LOCAL MEMBER CONCERN

APPLICATION No. **19/01533/MJR** APPLICATION DATE: 12/06/2019

LOCATION: 782-786 NEWPORT ROAD, CARDIFF

PROPOSAL: DEMOLITION OF EXISTING BUILDINGS AND PROPOSED MIXED USE DEVELOPMENT COMPRISING OF RESIDENTIAL, RETAIL AND ASSOCIATED PARKING

PROPOSED GROUND FLOOR SITE PLAN

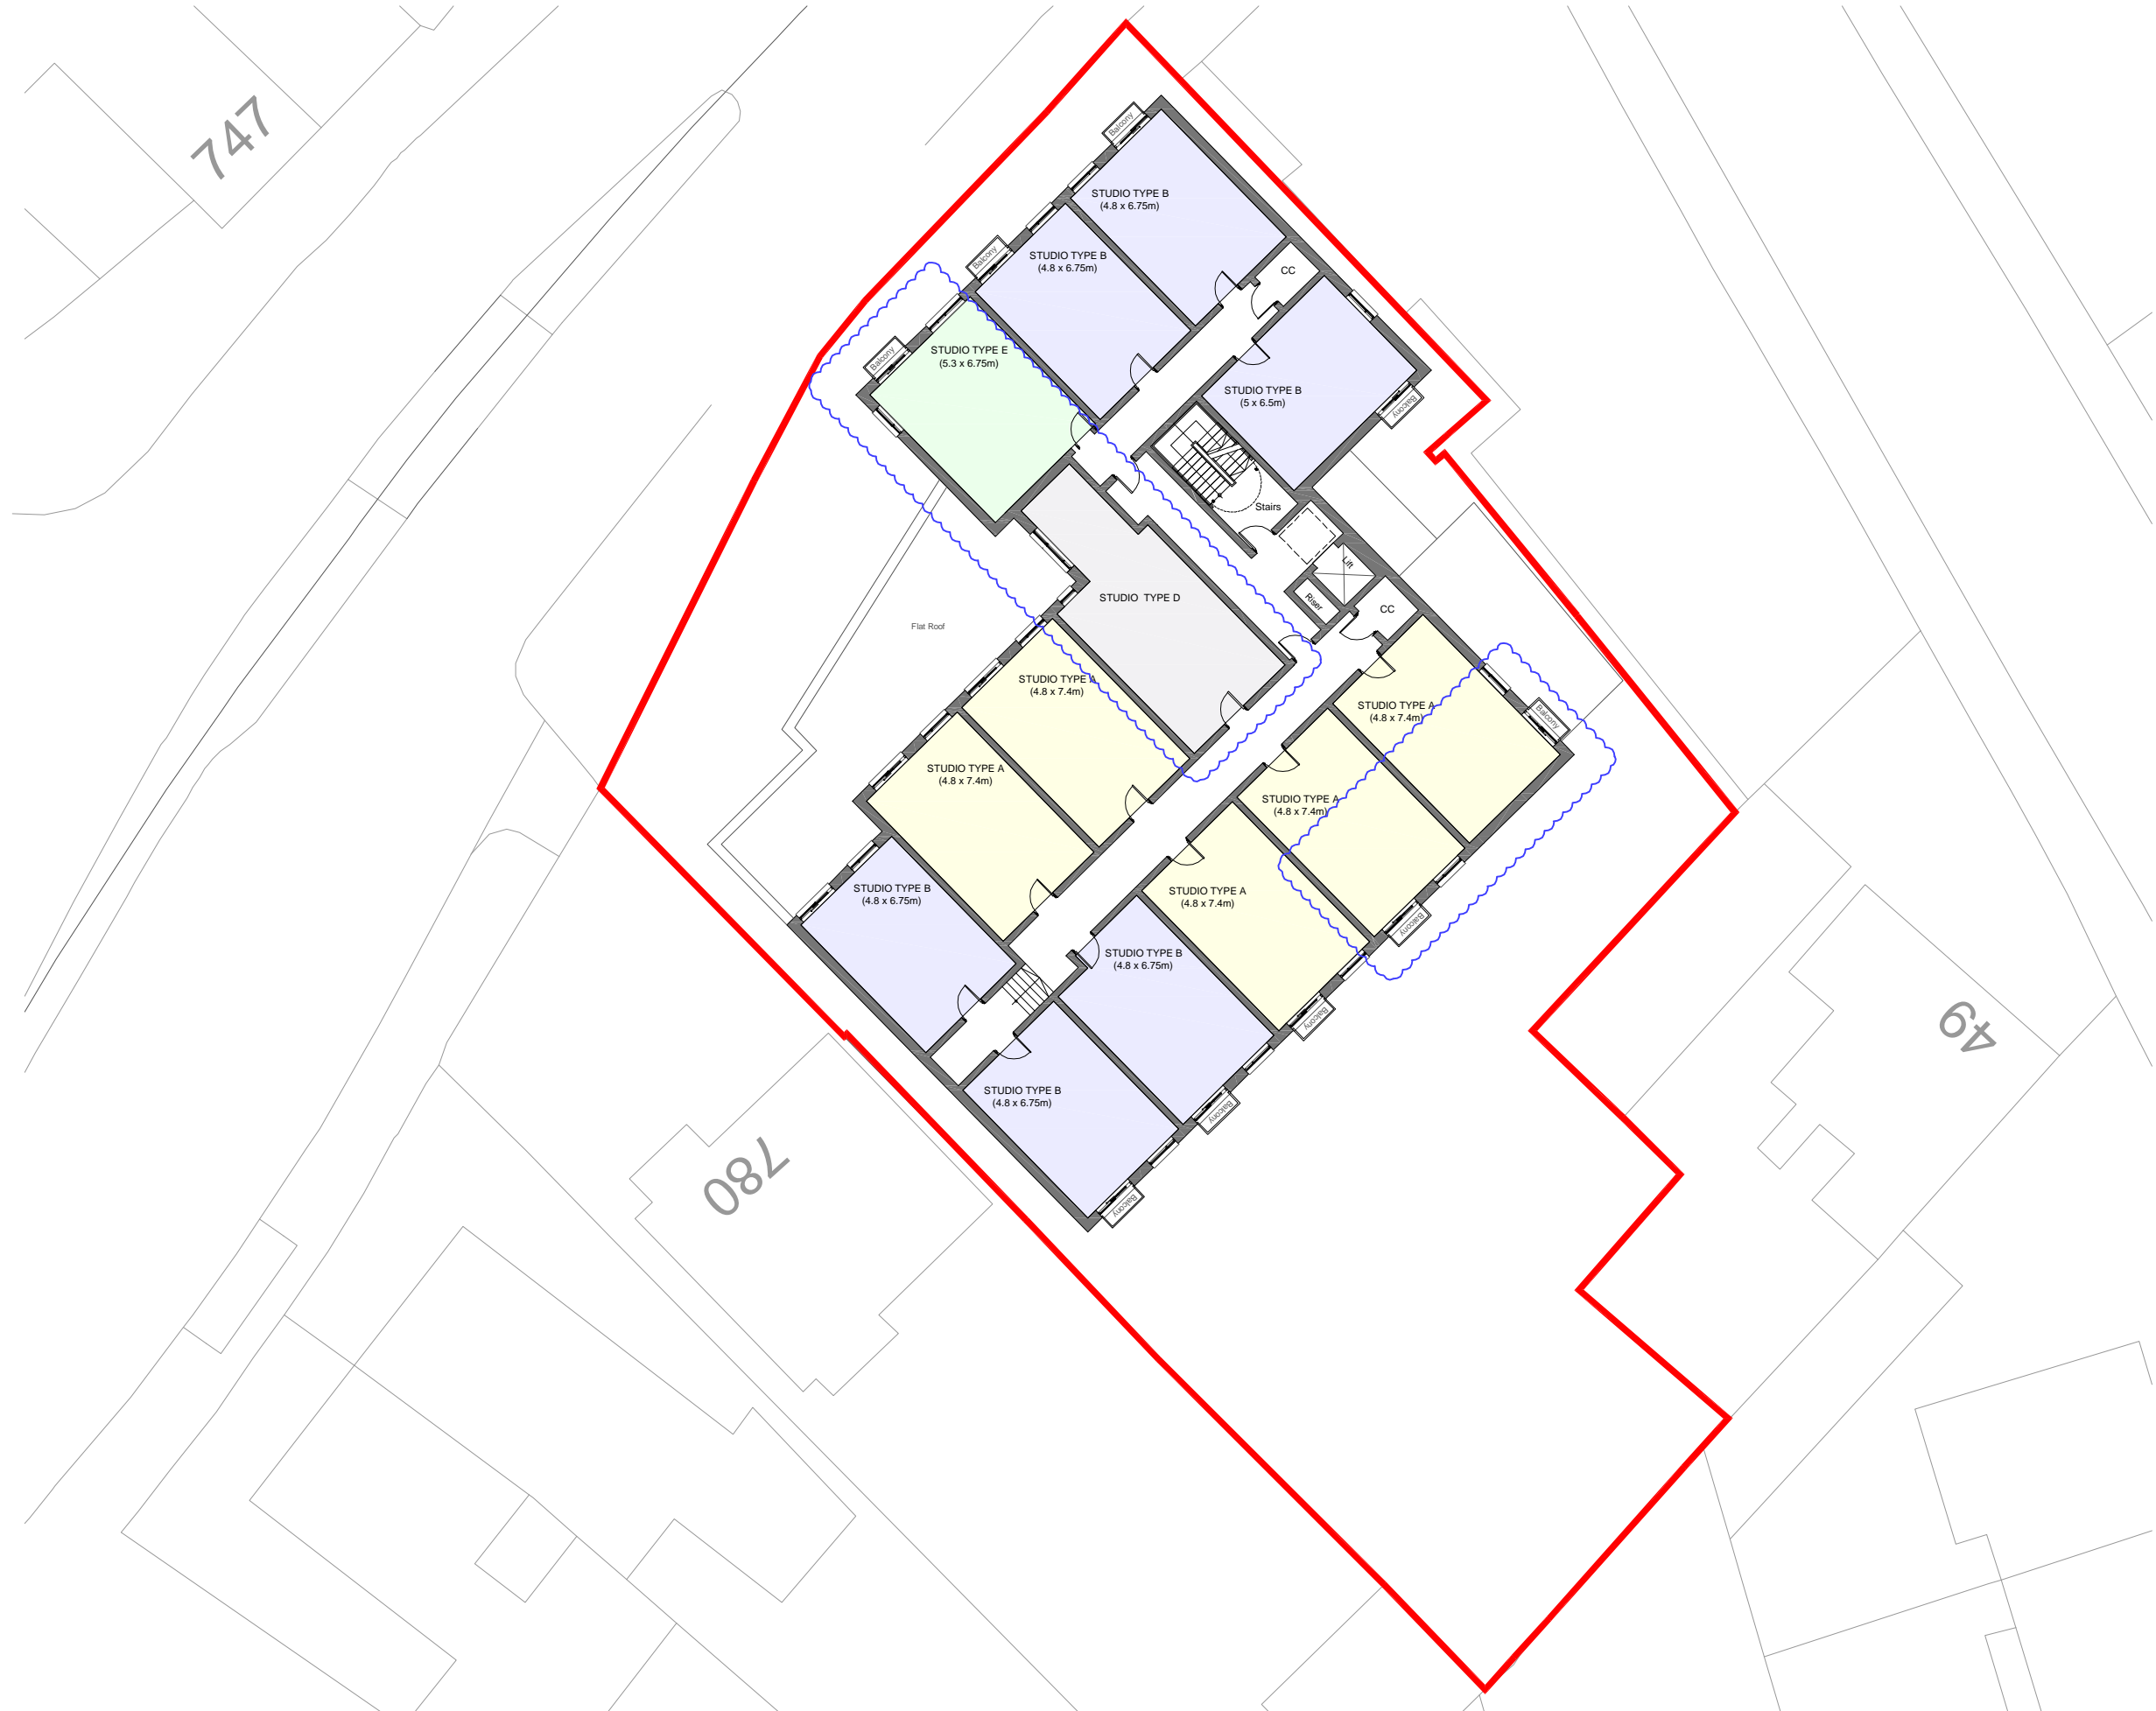
It is noted the road has been revised to be of 4.5m width and this is regarded as acceptable. It is noted that a pedestrian priority zone is to be provided. This could be conditioned, possibly as part of the public realm condition.

The plan now shows the double yellows as ending adjacent to the eastern side of the relocated access, and therefore there should not be a need for the TRO to be amended. Servicing/deliveries can take place to the north-east of the access road (outside the prohibited times indicated on the plate) from the main carriageway now that the dedicated service bay is not included, with deliveries for the southern building taken by foot/trolley from there.

The plans show an extensive area of footway/public realm in front of both units (a mix of adopted highway and private land) and we want to ensure this area does not become used as a parking area for customers/staff of the retail units. Whilst this can partly be dealt with via a public realm condition, we would request a Section 106 contribution of **£6000** to cover the potential for bollards/other street furniture to be placed in the carriageway should parking/traffic issues become apparent following opening.

Whilst the principle of the Josta 2-tier gas cycle parking type is acceptable, we need to see further details at this stage (preferably 1:100) of how this will work. The Ground Floor Plan indicatively shows the cycle parking but the 0.5m spacing lines only seem to provide for around 16 spaces? The door into this area should also be marked.

No existing street trees are affected by the development. The 4 proposed trees shown along the frontage on the layout plan should have a positive impact on the appearance of Newport Road which lacks street trees, but it is essential to establish that these are deliverable at this stage with sufficient root volume through use of below ground cells and absence of services.

The submitted details shall provide for x4 new trees on the Newport Road frontage and x1 new tree in the car-park to the rear as depicted on the Proposed Ground Floor Site Plan. The trees to the Newport Road frontage shall have access to a combined minimum root available soil

volume of 40 cubic metres provided as a continuous tree pit trench, or a minimum 15 cubic metres root available soil volume per tree if the tree pits are isolated rather than inter-linked. Root available soil volume shall be made available via load bearing soil cells with two aeration/irrigation inlets provided for every 5 cubic metres of root available soil. The tree in the car-park shall have access to a minimum 15 cubic metres root available soil volume via the planting bed and un-compacted soil within load bearing soil cells beneath car-parking combined. This tree shall be served by three aeration/irrigation inlets.

21. Prior to development commencing details of the proposed public realm area between the two retail units and the adopted footway on Newport Road shall be submitted to and approved in writing by the Local Planning Authority, to include details of the proposed surfacing, measures to ensure vehicular parking cannot occur there, and details of visitor cycle parking. Those details shall be implemented prior to beneficial occupation.

22. Prior to development commencing details of the proposed site access road off Newport Road shall be submitted to and approved in writing by the Local Planning Authority, to include details of the crossing points between the two retail areas, the position and format of the gates, and the delineated pedestrian priority zone. Those details shall be implemented prior to beneficial occupation.
